Site Plan Drawing_V2.pdf Markup Summary

VENETUCCI FARMS

A PORTION OF THE SW $\frac{1}{4}$ OF THE SW $\frac{1}{4}$ OF SECTION 11 AND A PORTION OF THE NW $\frac{1}{4}$ OF SECTION 14, EL PASO, COUNTY
 5202 HWY 85-87, 5210 HWY 85-87, 5304 HWY 85-87 & 5304 HWY 85
SPECIAL USE PERMIT - BUSINESS EVENT CENTER

PPR 21-053
 AL 21-015

UTILITIES PLAN

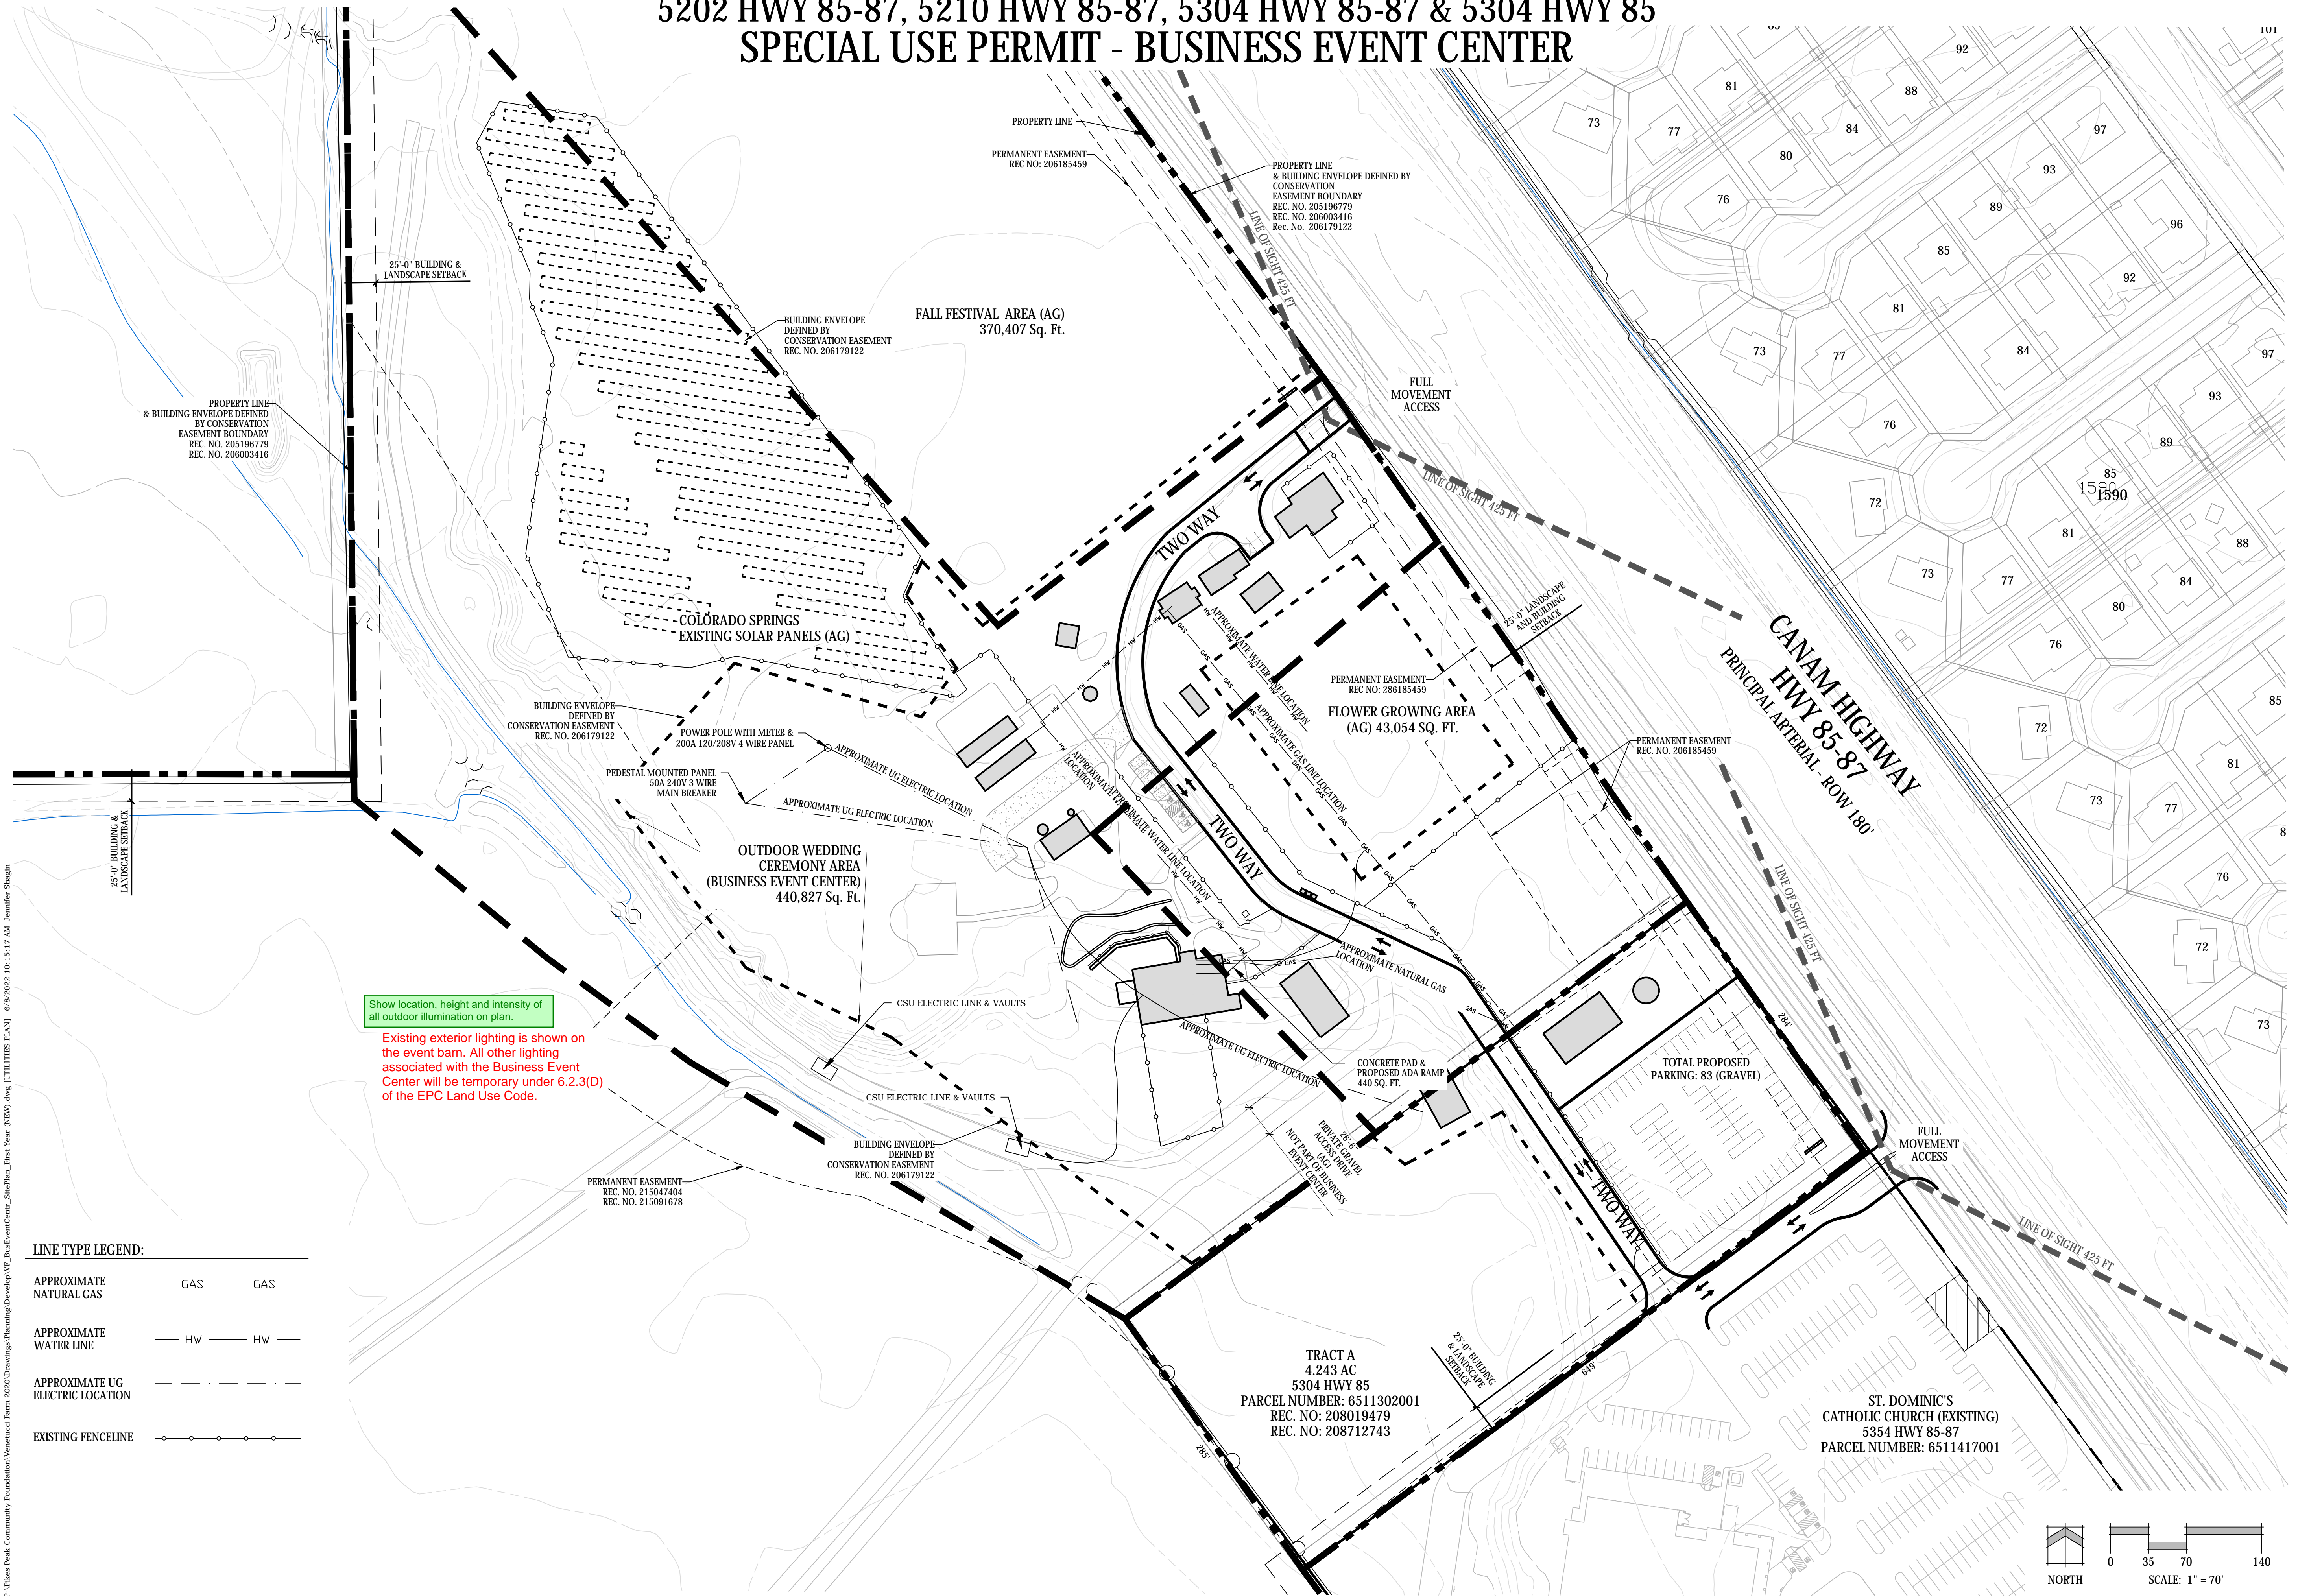
Show location, height and intensity of all outdoor illumination on plan.

Existing exterior lighting is shown on the event barn. All other lighting associated with the Business Event Center will be temporary under 6.2.3(D) of the EPC Land Use Code.

LANDSCAPE PLAN

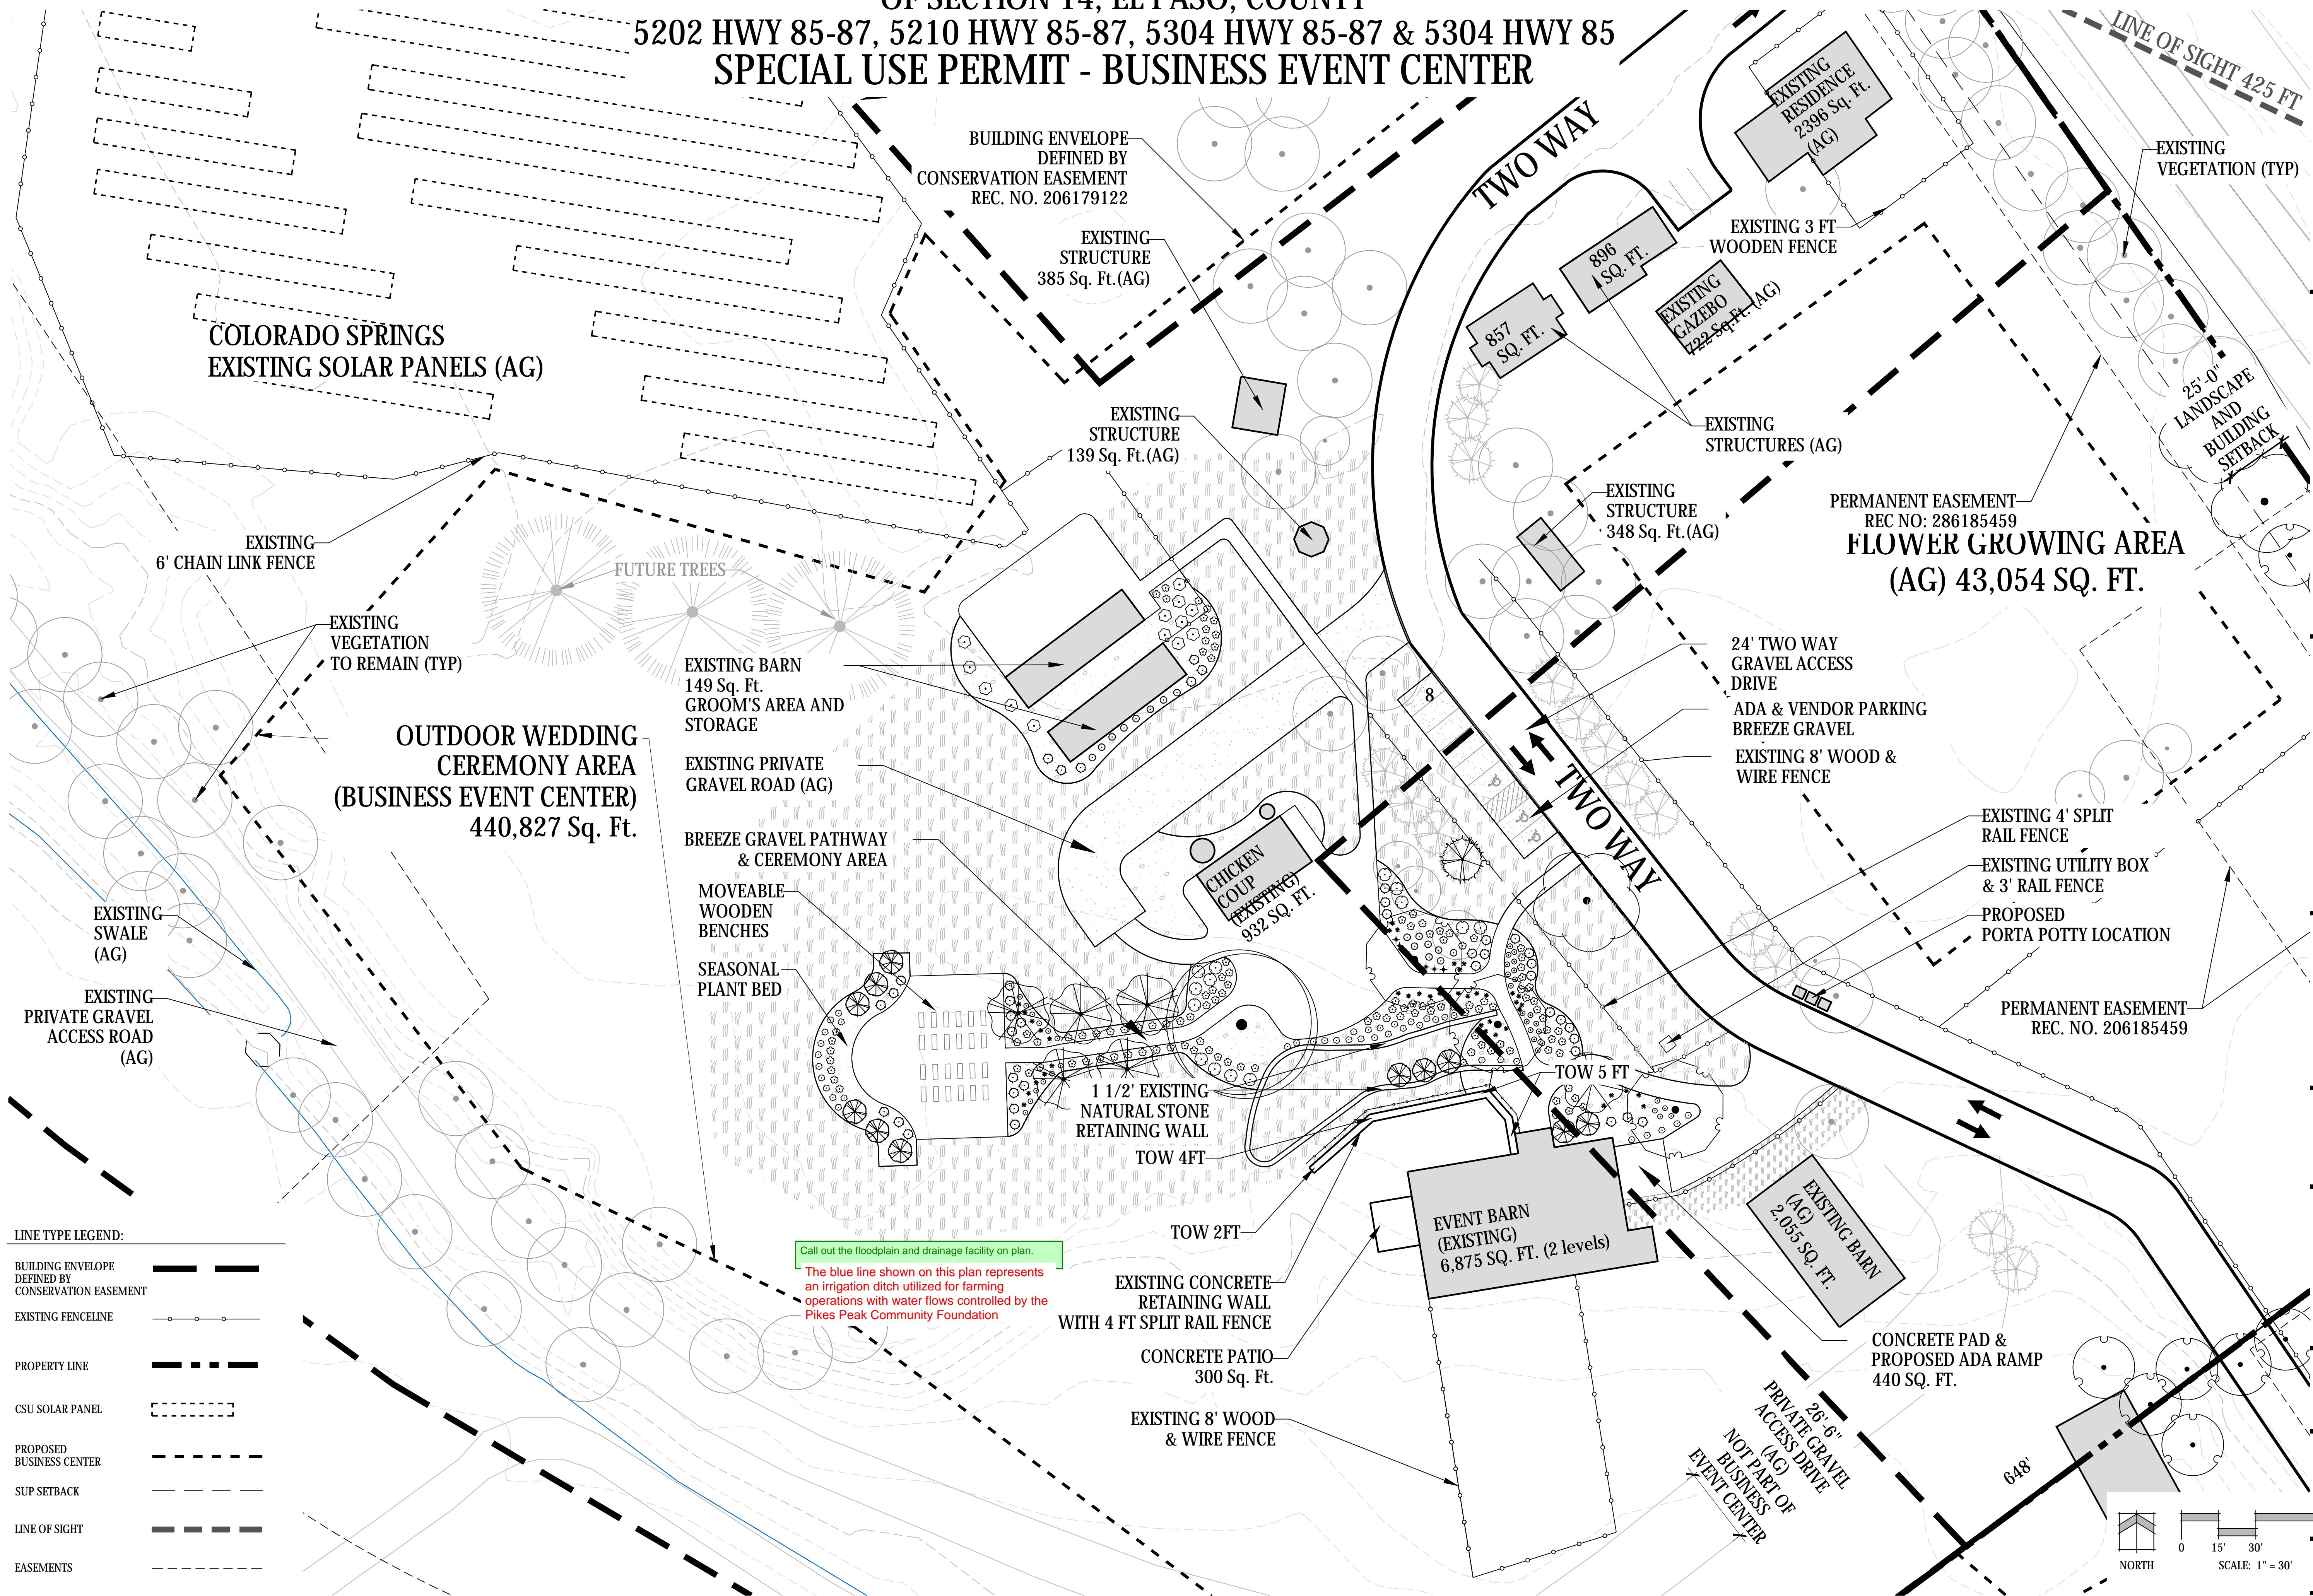
Call out the floodplain and drainage facility on plan.
The blue line shown on this plan represents an irrigation ditch utilized for farming operations with water flows controlled by the Pikes Peak Community Foundation

TRAFFIC CIRCULATION PLAN

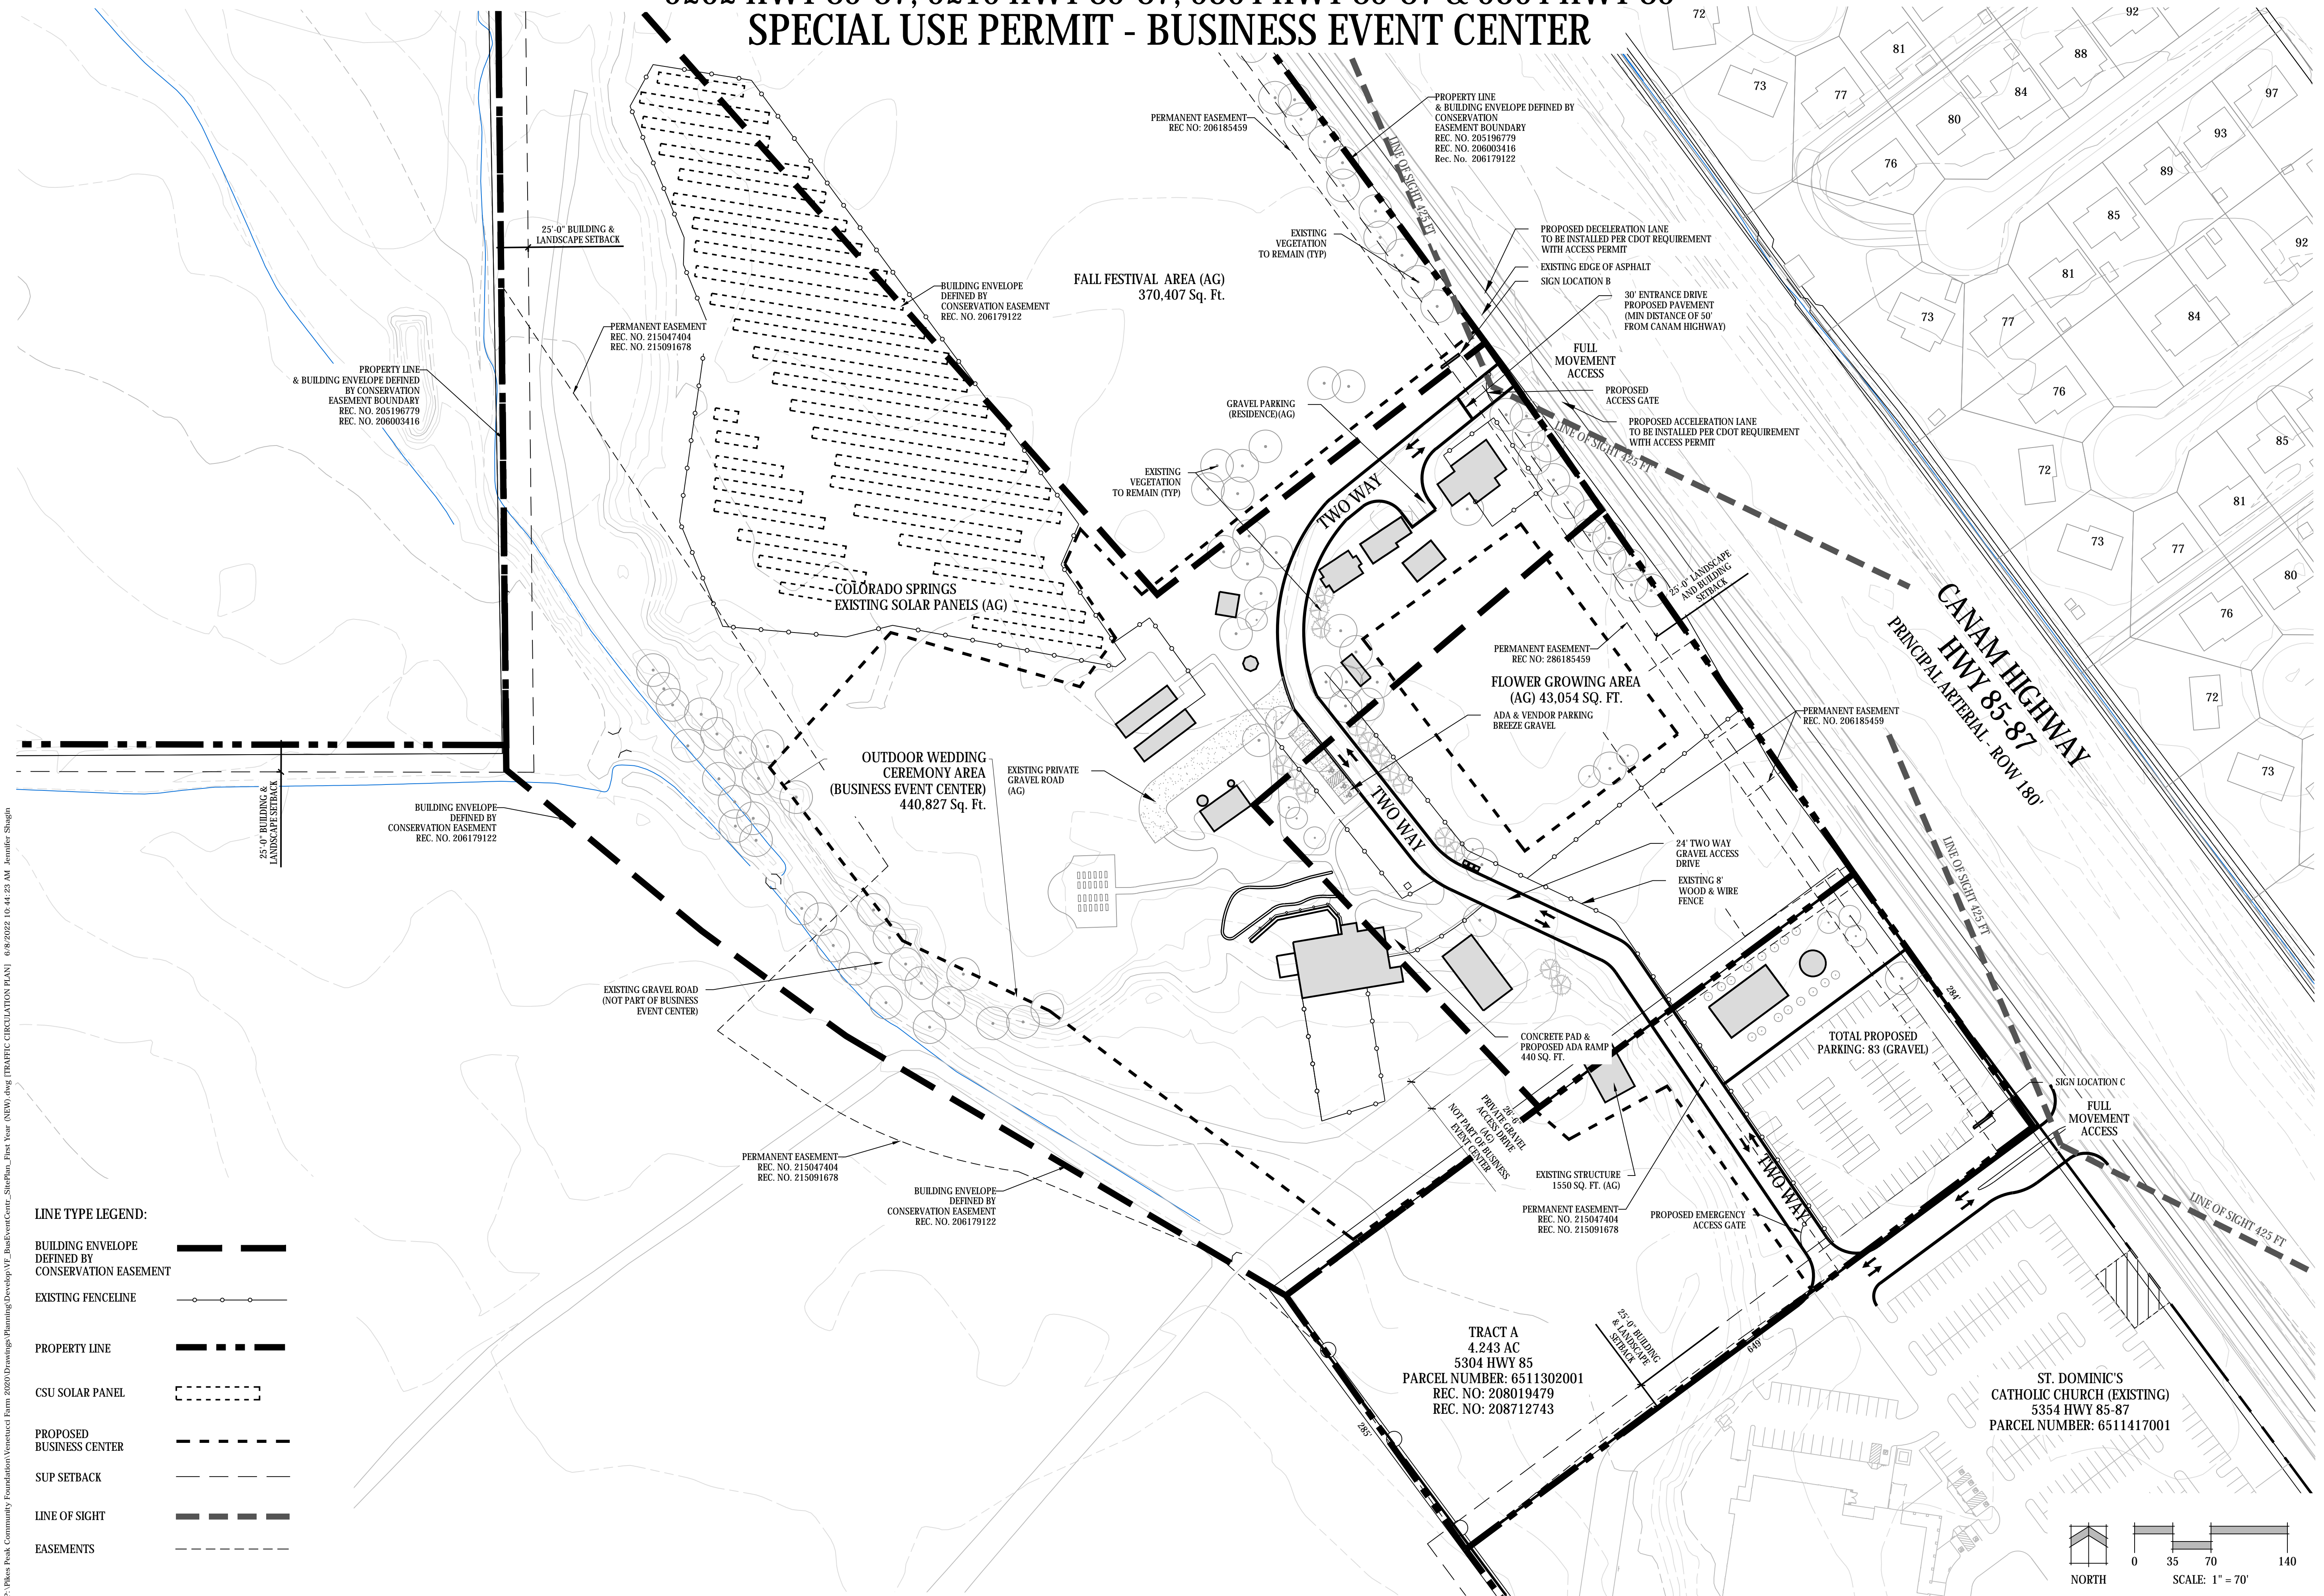
On the cover sheet, 4 ADA parking spaces were required and provided. Here on the plan only shows 3 ADA parking space. Please clarify and revise accordingly.

show location of dumpsters and loading dock area.
